Drawing Title: ELECTRICAL 3RD, 4TH AND 10TH FLOOR POWER ONE LINE SCHEMATIC AND RISER DIAGRAM

Project Title: RENOVATE FOR CLINICAL IMPROVEMENTS

Project Number: 583C16254
Building Number: 1
Drawing Number: EP-600
3FY12

1 EP600 3RD, 4TH AND 10TH FLOOR ONE LINE DIAGRAM/ RISER DIAGRAM
SCALE:NTS

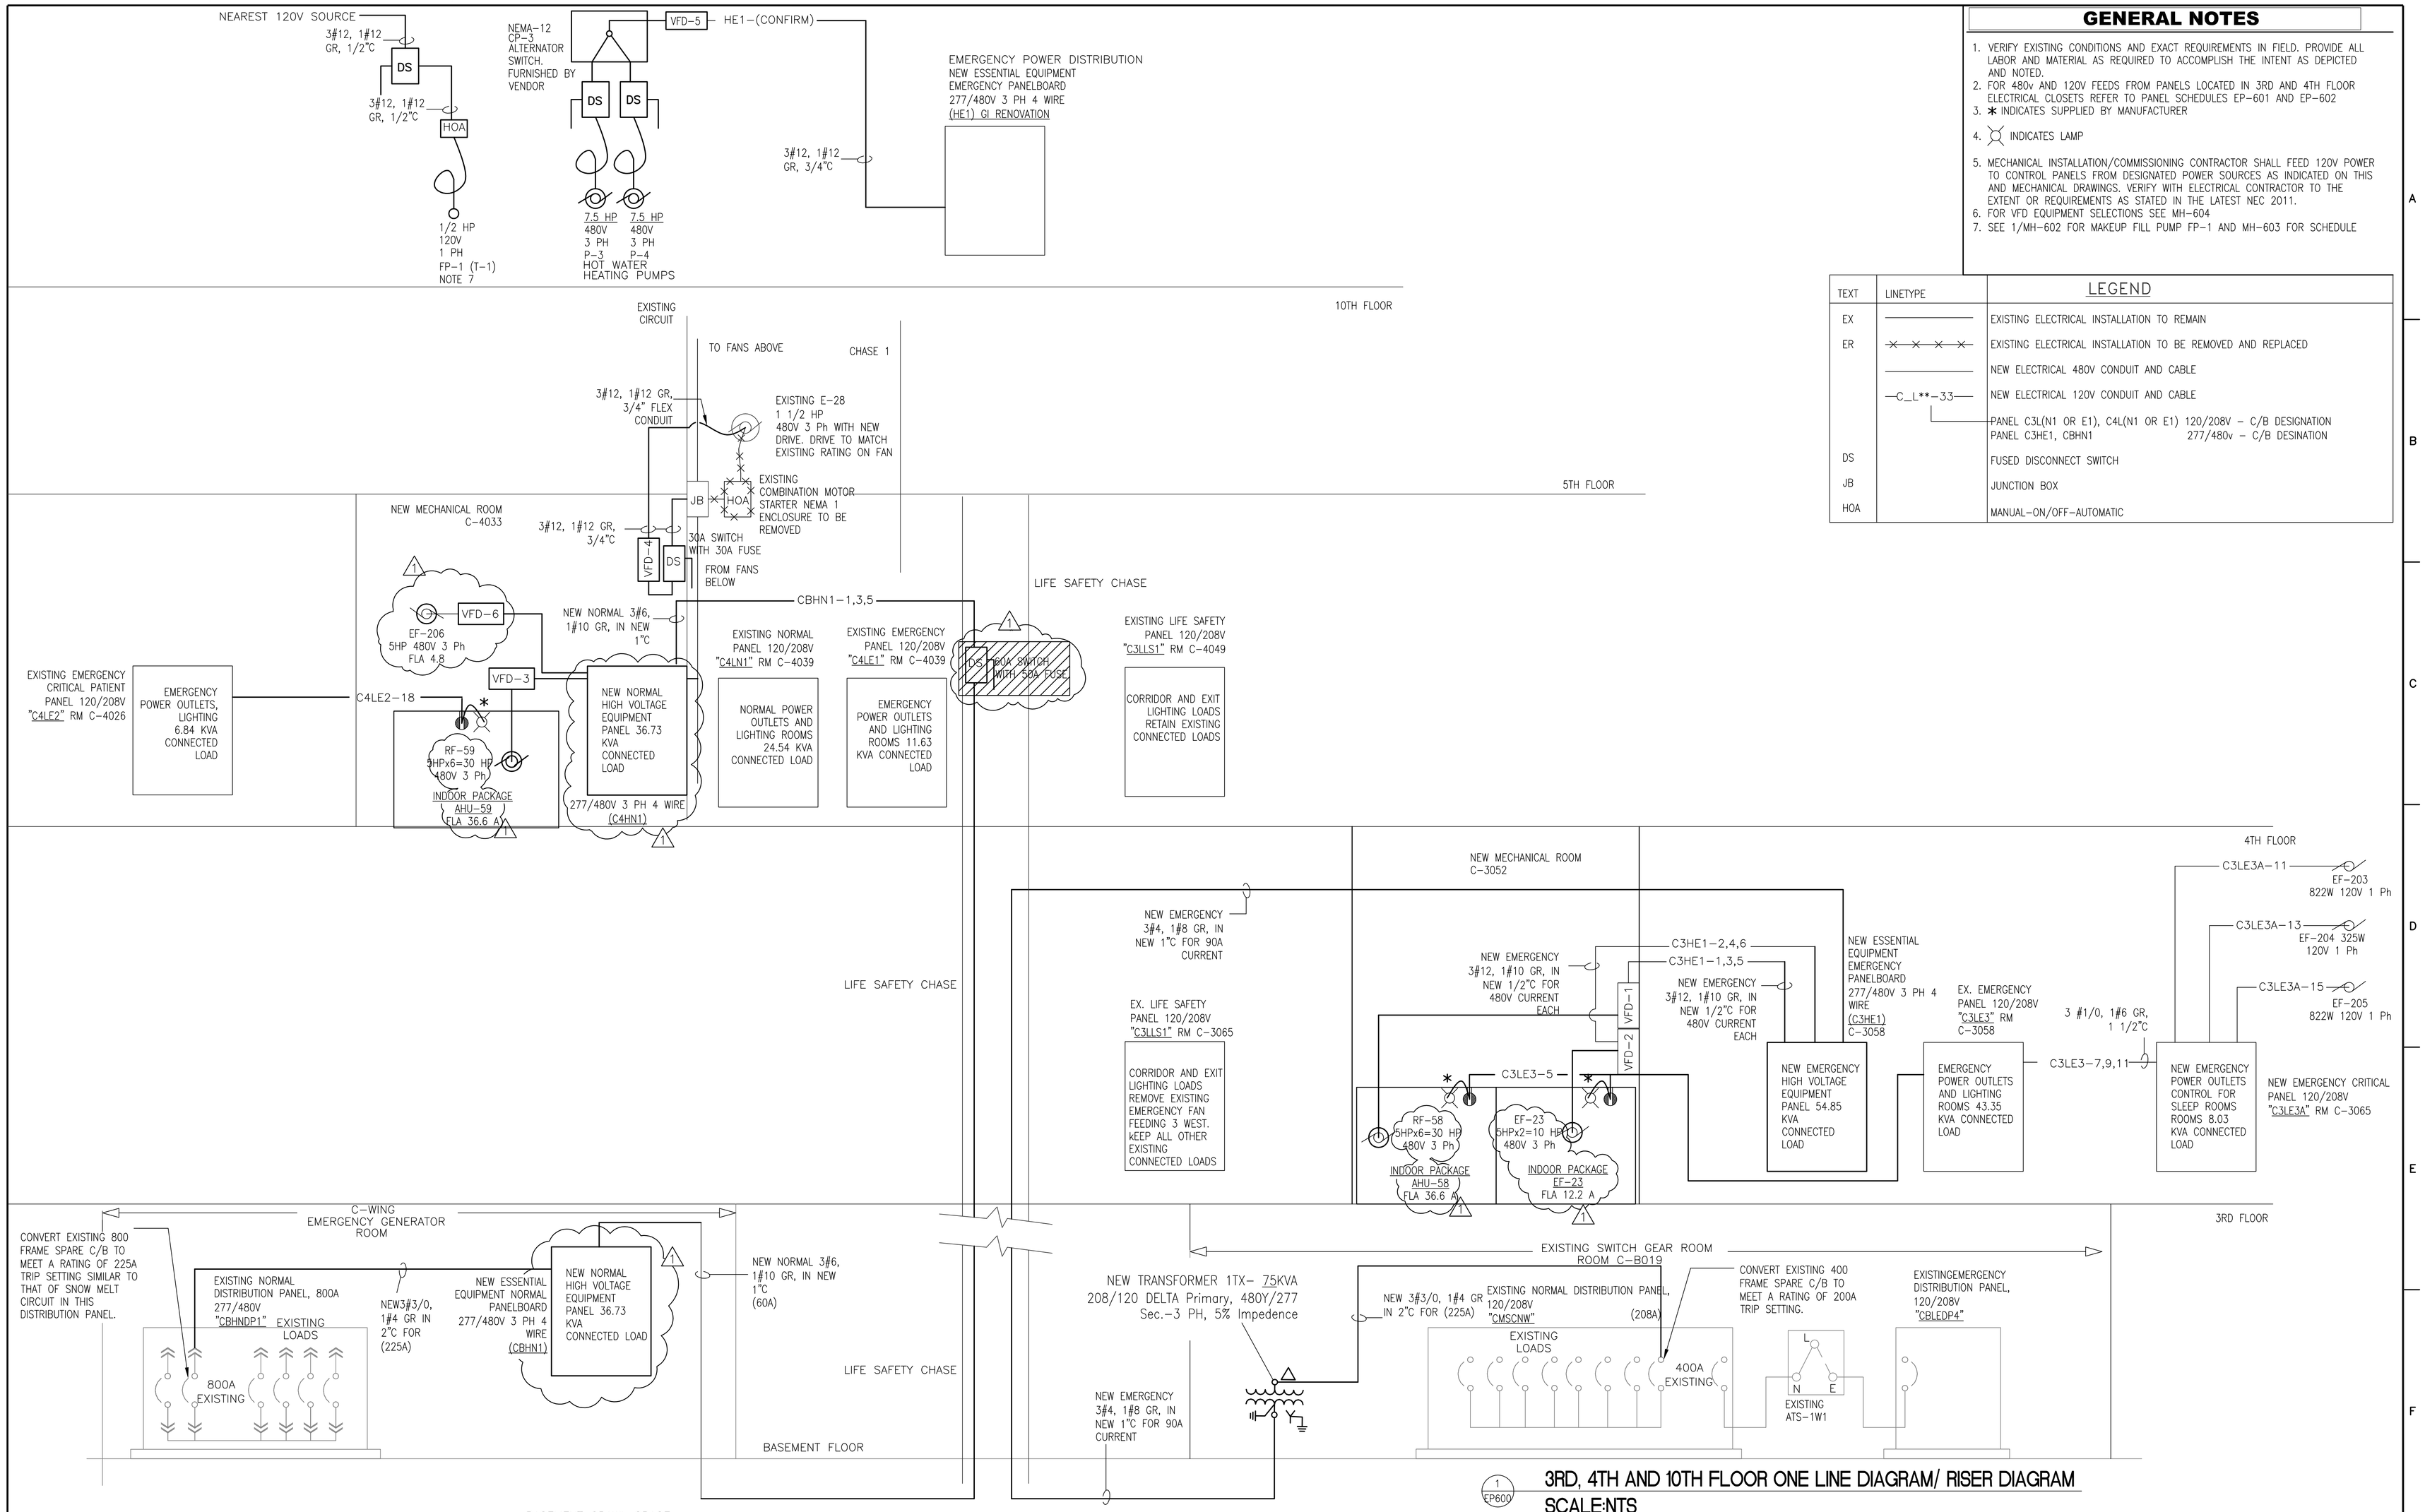
Revisions:	Date
65% SUBMITTAL SET	01.07.2012
95% SUBMITTAL SET	03.07.2012
BID DOCUMENTS SUBMITTAL SET	05.14.2012
REVISION - ADD EF-206 VFD-6 AND PANEL C4HN1	8-28-2012
REVISION - CHANGED EF-23, AHU-59, AND AHU-58 MOTOR	8-28-2012
REVISION - CHANGED CORRESPONDING WIRE SIZES	8-28-2012
REVISION - REMOVED DISCONNECT TO 4TH FLOOR	8-28-2012

2 MH401 ENLARGED MECHANICAL ROOM PLAN
SCALE: 1/2" = 1'-0"

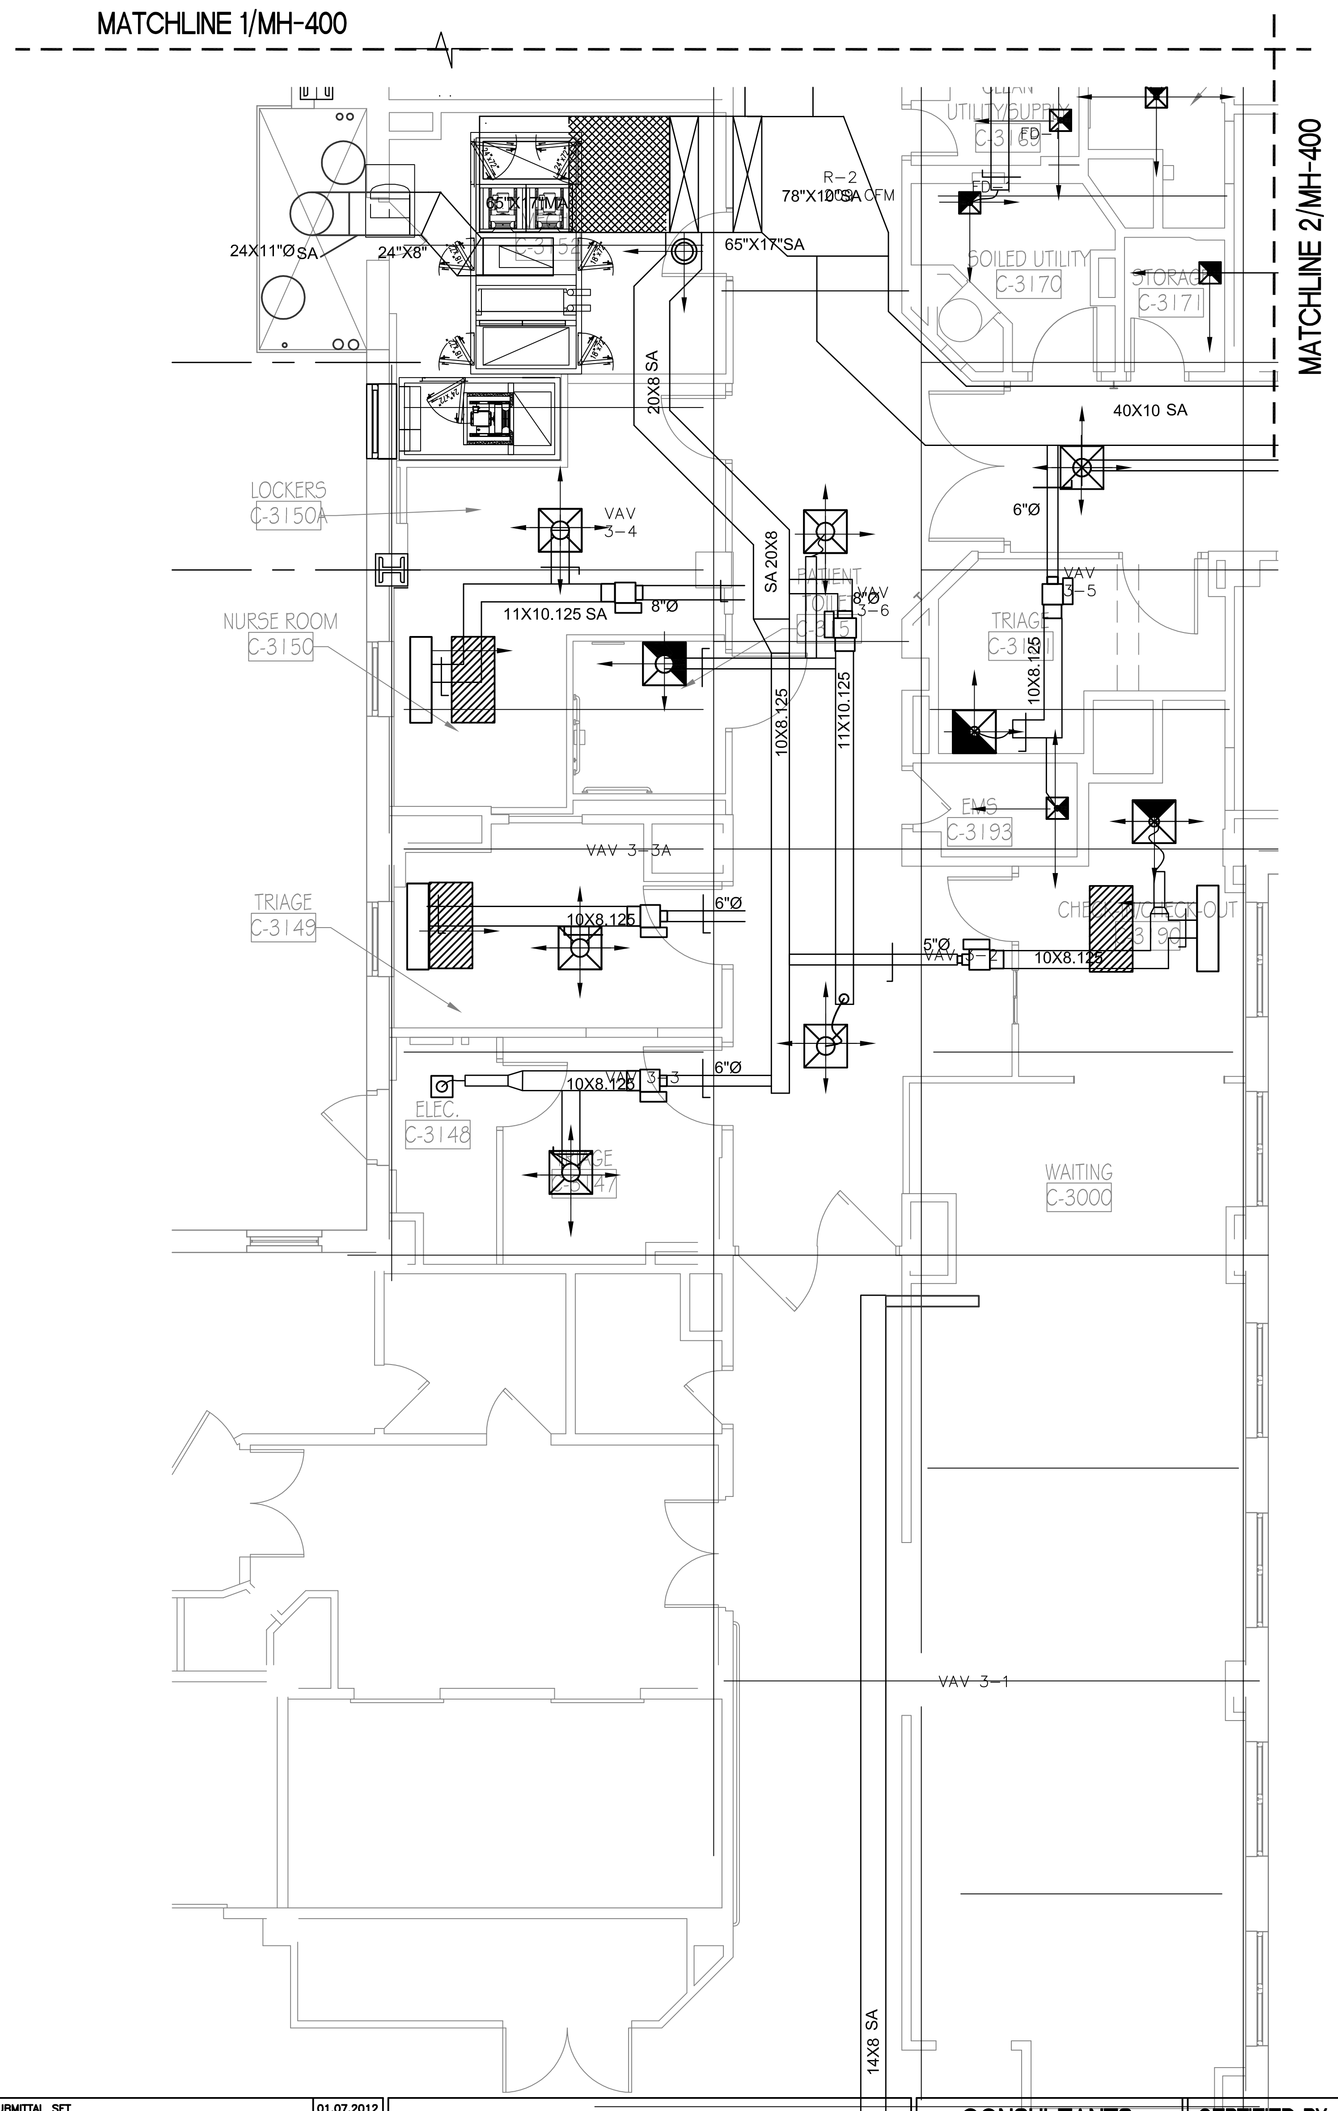
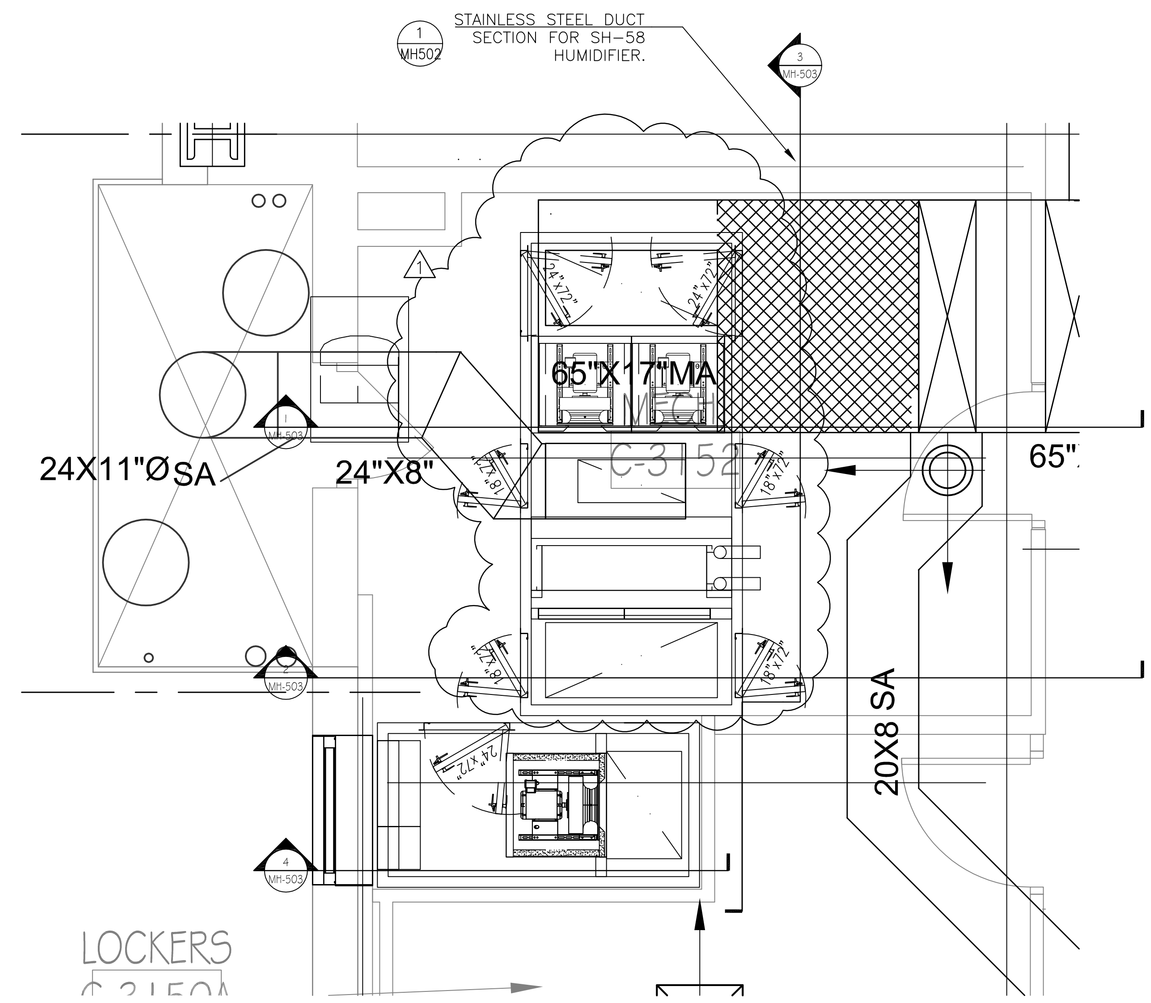
1. THE DRAWING ARRANGEMENT SHOWN IN DETAIL 2 SUPERSIDES ARRANGEMENTS SHOWN ELSEWHERE IN OTHER DRAWING PLAN ARRANGEMENTS(OVERALL AND MECHANICAL PLUMBING). THOSE SHOULD BE USE FOR REFERENCE ONLY. CHANGES SHOWN TO AHU-58 PERTAIN TO THE ARRANGEMENT OF THE AIR HANDLING UNIT SECTIONS AND INCLUDE AN OUTSIDE AIR CONNECTION TO THE UNIT.
